Access Compliance Report

Public Rights-of-Way

Intersection ID: 3104	Main Street: DUVALL_MEADOW_LN	Cross Street: LOMAX_RIDGE_DR	Location: S
ADA ID: 82D21ECCE390	Ramp Type: BlendTrans1	Initial Pass/Fail: Pass	Overall Compliance: No
Severity Score: 2.75			
Codes/Mitigation Info/Possible Solution		Field Measurements/Component Compliance

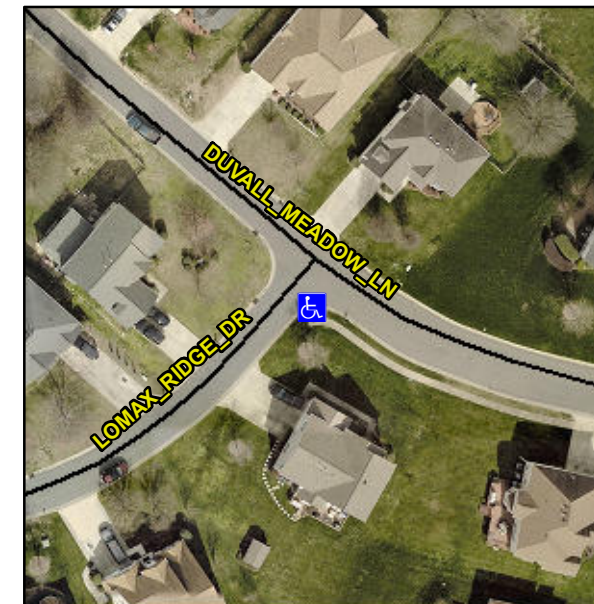
Remove & Replace Curb Ramp With Two New Directional Ramps or Equivalent. Remove & Replace Gutter.

R304.5.3, R304.2.1, R304.2.2-Perp, R304.3.2-Para, R305.1.4
